# UNITED STATES PATENT AND TRADEMARK OFFICE

APPLICATION NO.	FILING DATE	FIRST NAMED INVENTOR	ATTORNEY DOCKET NO.	CONFIRMATION NO.
10/534,767	05/12/2005	Alain Durr	16528.2a.3a	8884
22913	7590	06/22/2010	EXAMINER	
Workman Nydegger 1000 Eagle Gate Tower 60 East South Temple Salt Lake City, UT 84111			KASHNIKOW, ERIK	
			ART UNIT	PAPER NUMBER
			1782	
			MAIL DATE	DELIVERY MODE
			06/22/2010	PAPER

### Office Action Summary

## DETAILED ACTION

Fig 1d

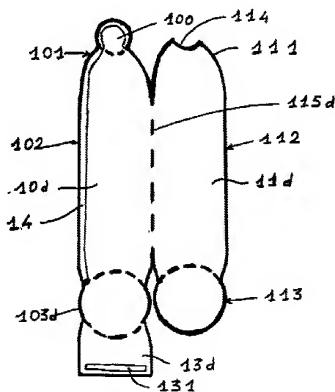
13. In regards to claims 1, 14 and 24 the protective article of Block comprises 2 "bottle projections" (1<sup>st</sup> page 7<sup>th</sup> and 8<sup>th</sup> paragraphs and Figure 1d) which one of ordinary skill in the art would recognize as half, that is configured to lie fully against the container wall (Fig. 1d). Block teaches that the half

shells are formed from a single piece and are joined by a line of folding (2<sup>nd</sup> page 3<sup>rd</sup> full paragraph, reference 115d in Fig. 1d) the edge of the first shell and the edge of the second shell are kept in direct contact. One of ordinary skill in the art would recognize

that the line of folding would mean that the two sides are hingedly connected, it is also noted that line of folding in figure 1d of block is the same as the hinge in figures 2 and 3 of the instant application.

15. In regards to claims 20, 21 and 25, figure 1d shows embodiments wherein the line of folding (also the generatrix) is substantially the same as the entire length of the bottle, a preformed shoulder portion that accurately extends between the body and neck portion connecting them as well as portions wherein the neck portion protrudes away from the first and second half shells and extends around the entire neck (Figs 1b, 1c, 1d, 2d and 3c). Further Block teaches that the neck of the bottle is to be covered (1<sup>st</sup> page 10<sup>th</sup> paragraph).
